Staff Report

Re: PLNSUB2018-00033 - Hopkins Estate Planned Development
PLNSUB2018-00034 – Hopkins Estate Preliminary Subdivision

PLANNED DEVELOPMENT & PRELIMINARY SUBDIVISION

Proposed site plan—applicant is requesting reduced front (green) and rear (blue) yard setbacks for lot 1.

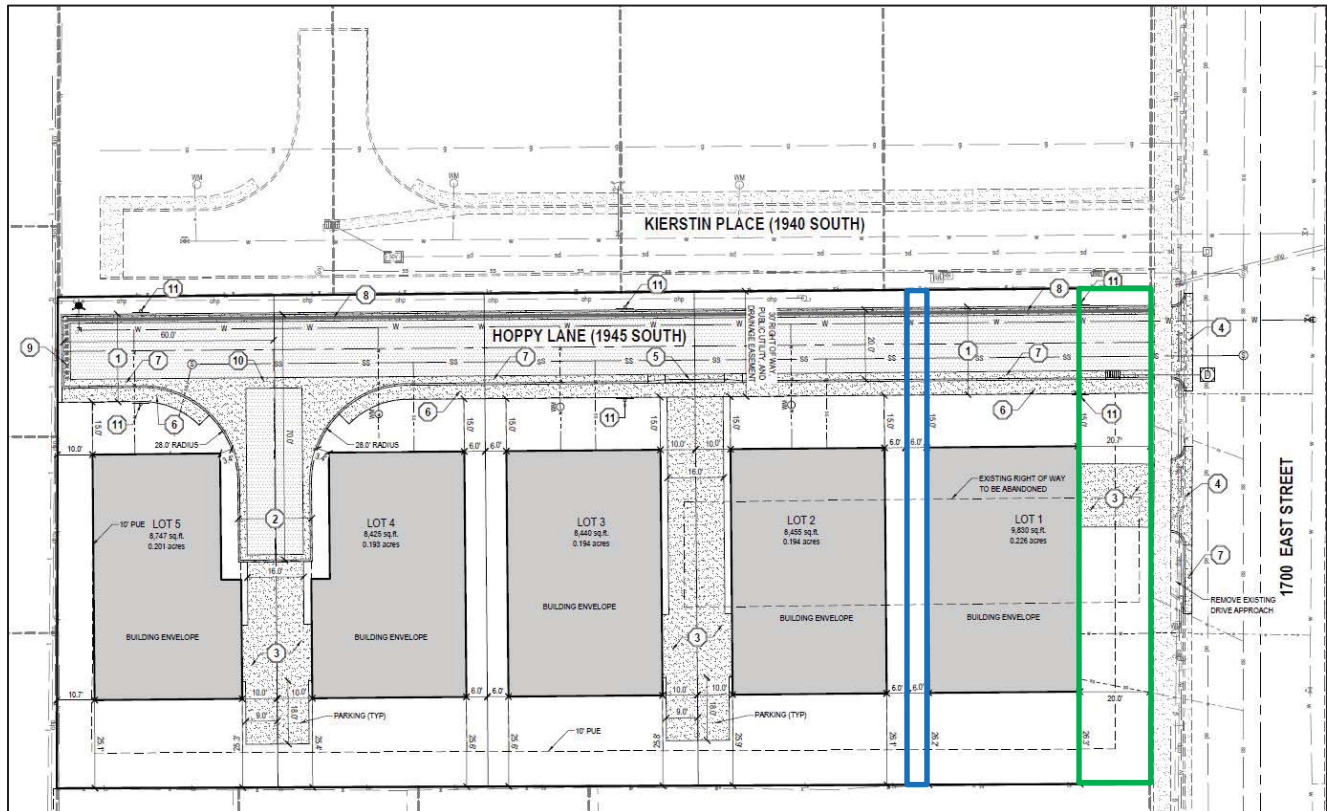
Planned Development approval is required for this project due to lots 2-5 not having frontage on a public street. In addition, the applicant is requesting reduced front and rear yard setbacks for the home on lot 1. Per code, *the minimum depth of the front yard for all principal buildings shall be equal to the average of the front yards of existing buildings within the block face*. Staff estimates that the average front yard depth along the block face is approximately 27 feet; the applicant is requesting 20 feet. In addition, the rear yard shall be a minimum of 25 feet, and the applicant is requesting 6 feet. Even though this seems like a large discrepancy, the rear yard of lot 1 functions more like an interior side yard, so Staff finds that the 6 foot setback is appropriate when the larger context is considered. Since the future homes on lots 2-5 would be oriented toward the proposed private driveway, the applicant has designated the north side of those lots the front yards, the south side of the lots the rear yards, with the remainder being interior side yards. Under those designations, the proposed envelopes on lots 2-5 have been designed to meet the minimum front, rear, and interior side yard setback requirements for the R-1/7,000 zone.

SITE PLAN

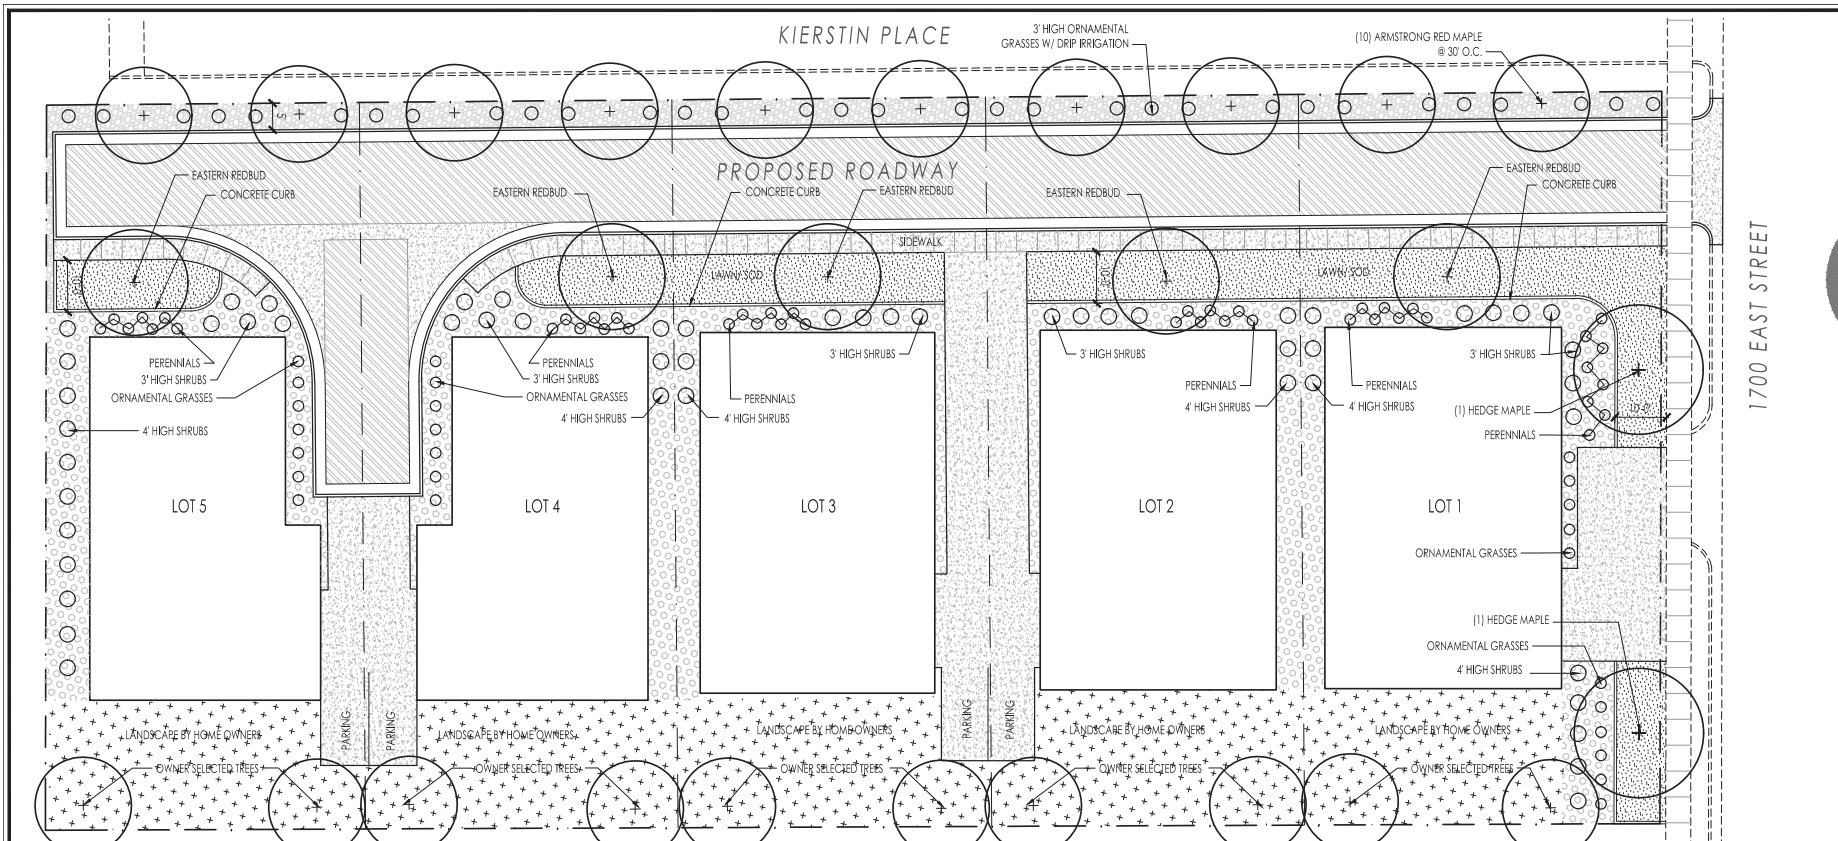
- Past the garage access locations, the site plan shows extra guest parking spaces (one for each home), which I'm assuming would also serve as the turn-around space for backing out of the garages;

- The future home on Lot 1 will be accessed via driveway off of 1700 East. The site plan also shows an extra parking space contiguous with this driveway, but I don't believe that would be permitted in the front yard.

During the building permit review process for homes built on lots 2-5, the plans will need to show that there is a minimum dimension of 22 feet, 7 inches between the garage entrances along the shared driveways. The applicant revised the plans to remove the extra parking space within the front yard on lot 1.
